10 October 2003

From: William S. Higgins *W.S.H.*

Subject: Linac-Mucool Shielding Wall

NEW CONFIGURATION

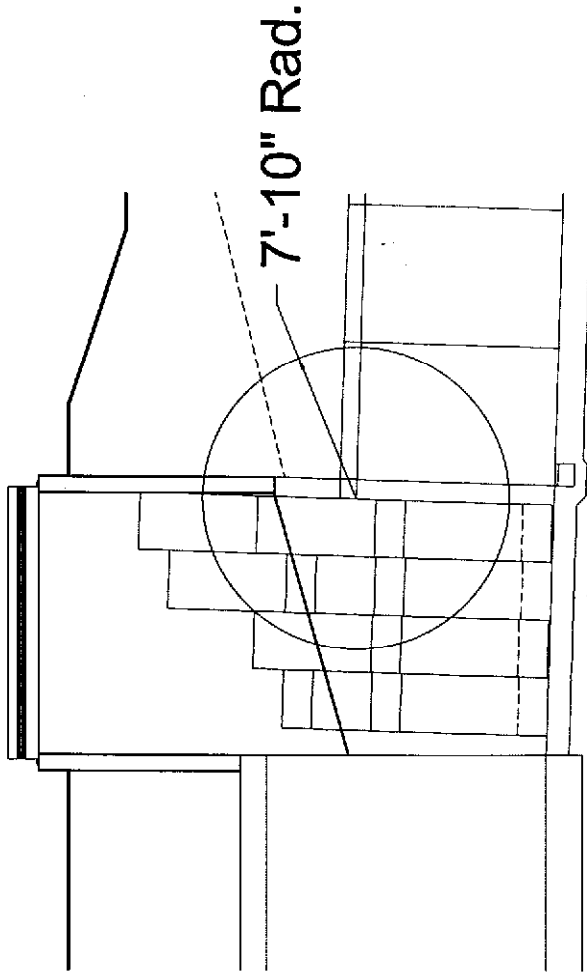
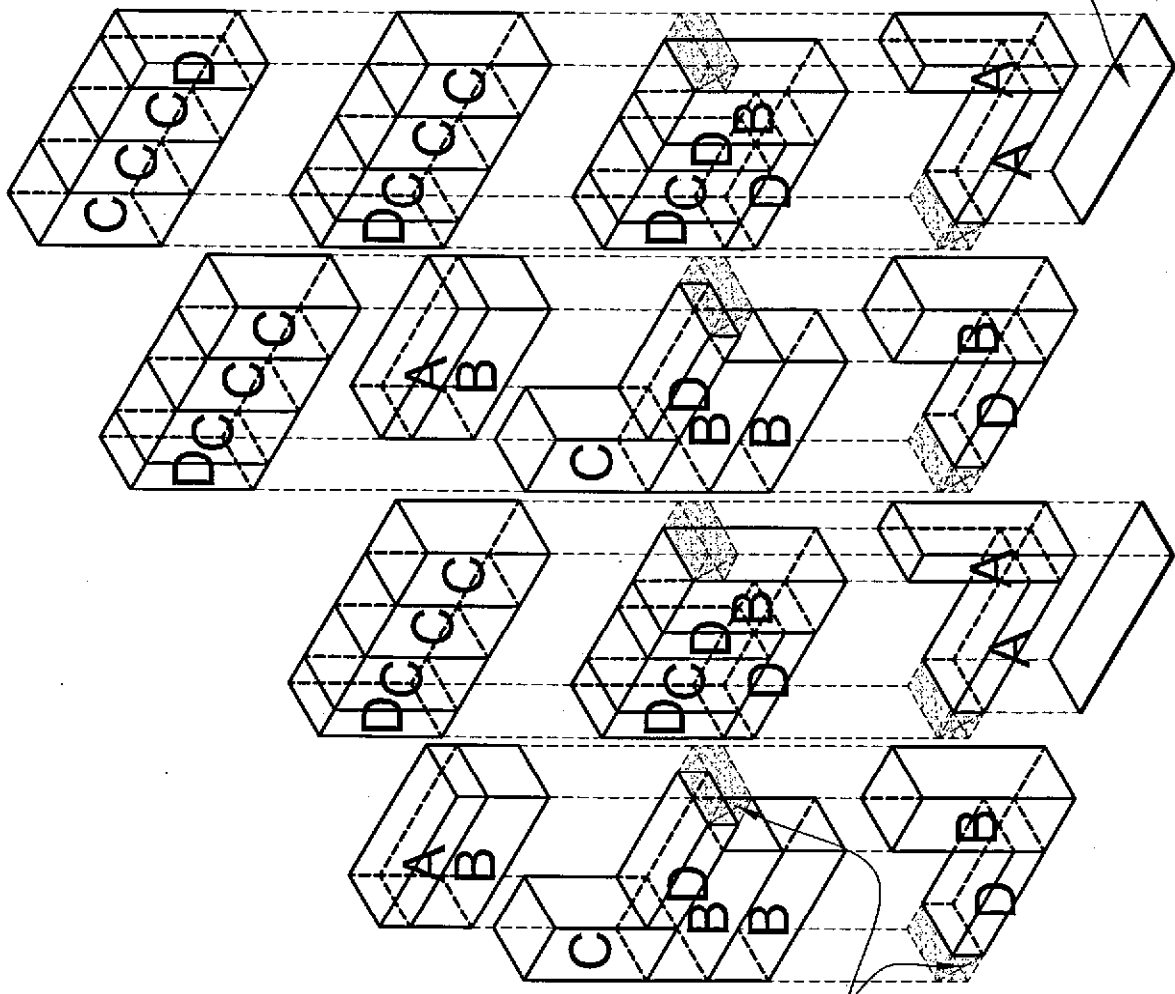
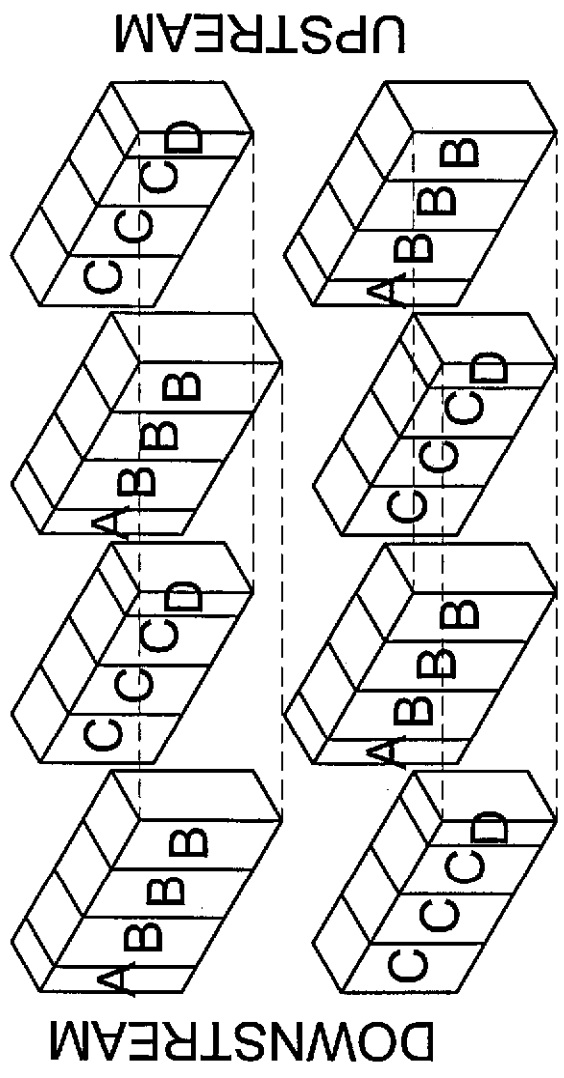
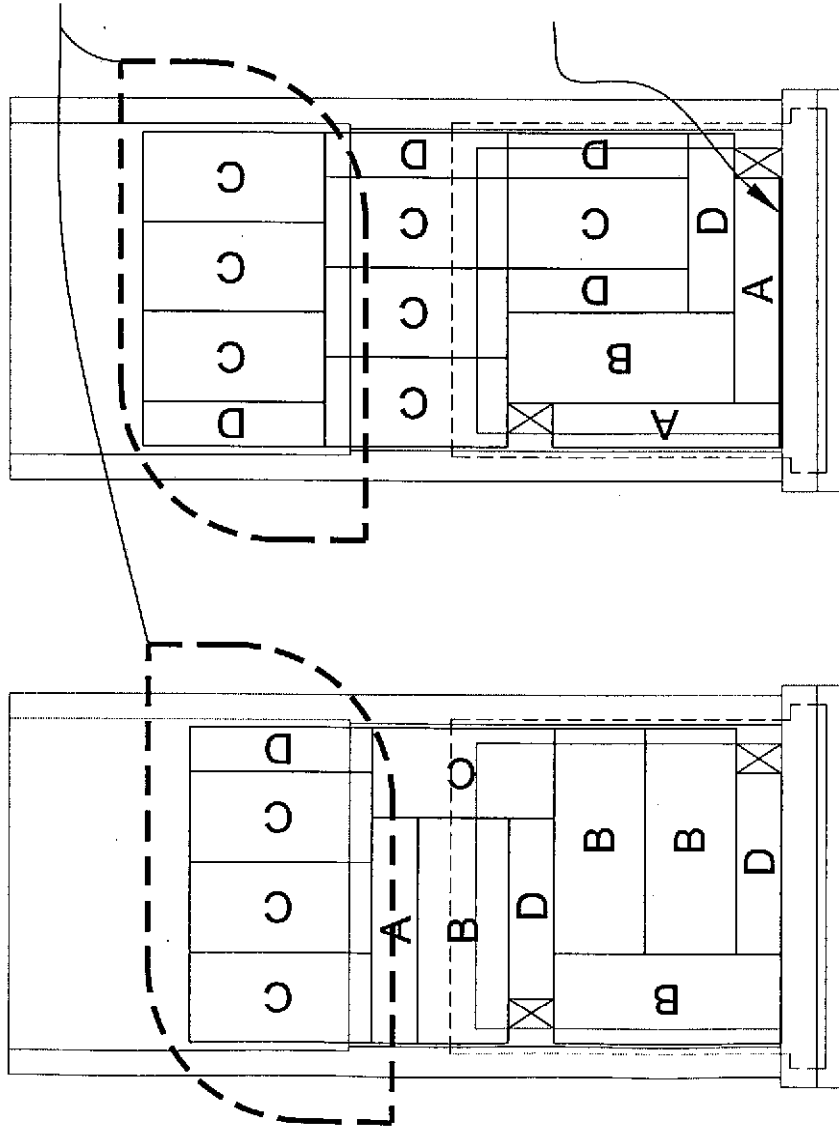
The blocks in the shield wall have now been replaced in a new configuration, detailed in the attached drawings and photos.

This configuration meets or exceeds the shielding provided by the previous shield wall. Thus it should suffice for the operation of the Linac.

There are two new penetrations in this wall. These have been filled with sandbags. Ropes on the sandbags extend into the Linac and Mucool enclosures to enable removal when necessary.

Bulkhead and
fill with sand at
openings

Place these blocks
at the two upstream
sections only

FIGURE 1

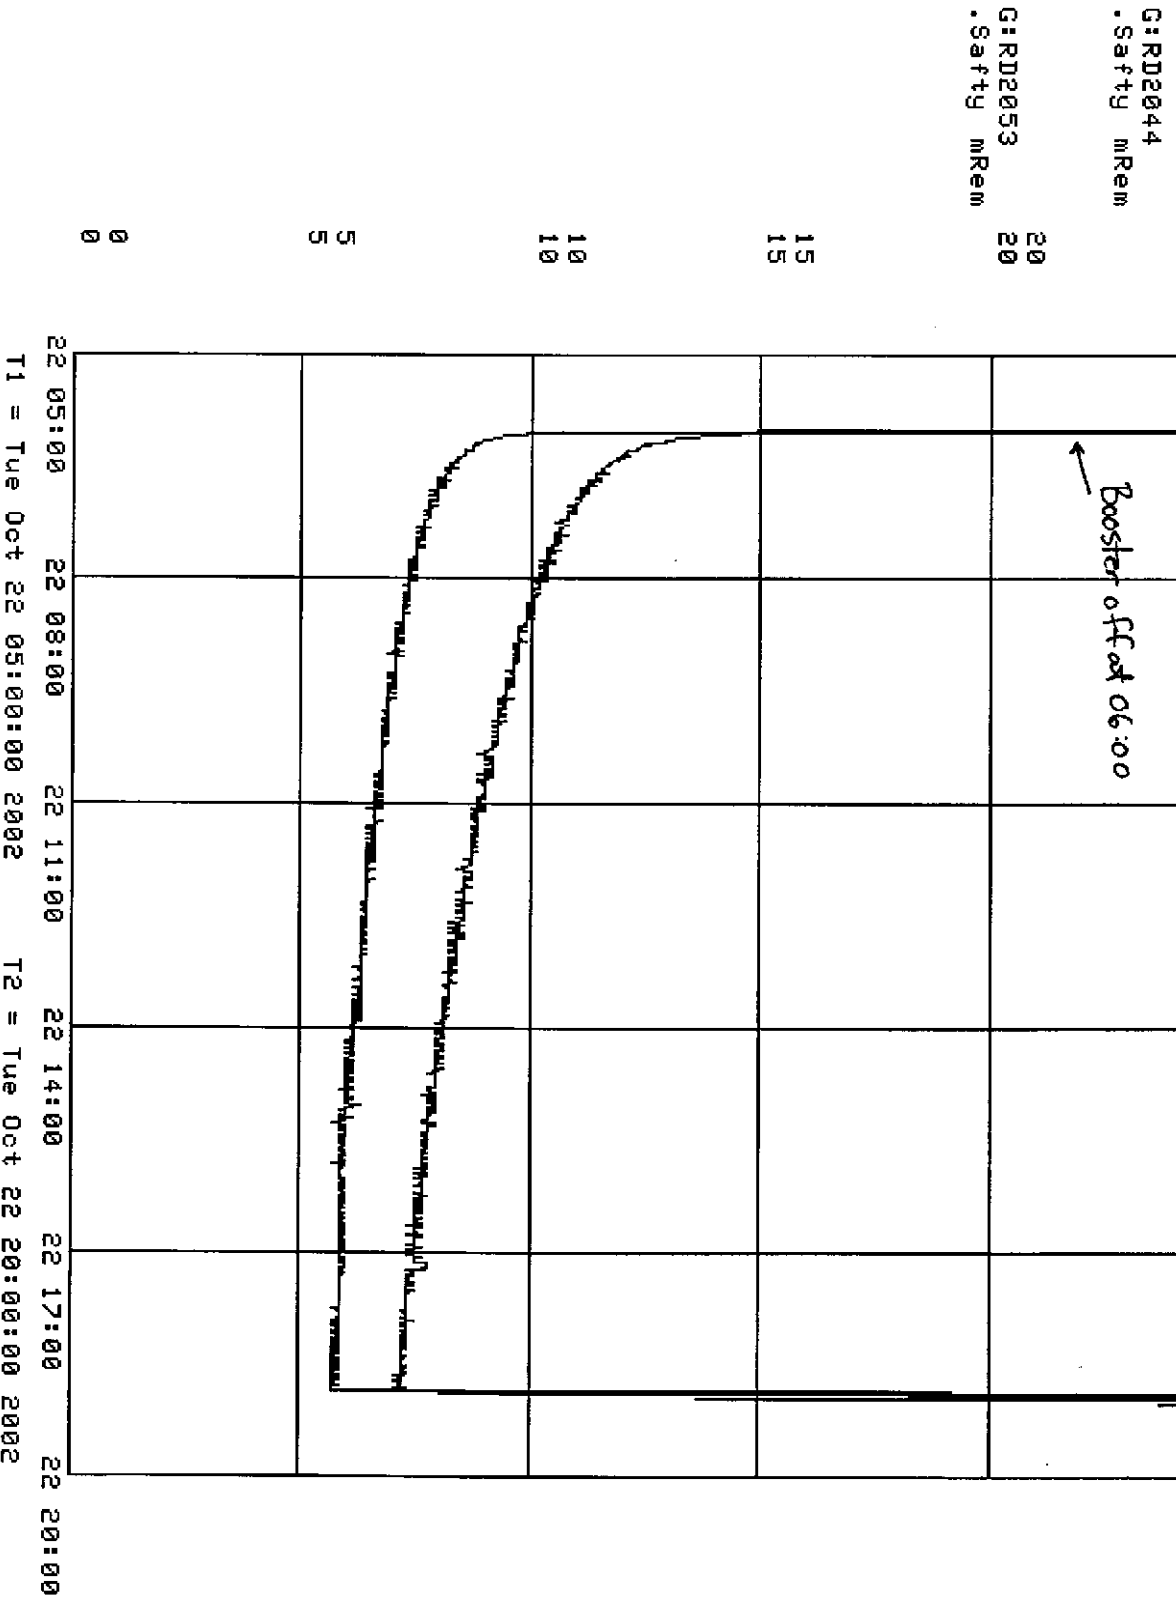
During a recent shutdown when Booster was in access and Linac was open, the key detector that held Linac off, referenced in the ACNET control systems as G:RD2053, was below 15 mRem/hr immediately when the enclosure opened at 06:00, see attached figure #1. It took an additional 2.5 hours for it to drop below the 10-mRem/hr trip level to allow Linac beam to run. The other detector, G:RD2044, was below 10 mRem/hr immediately.
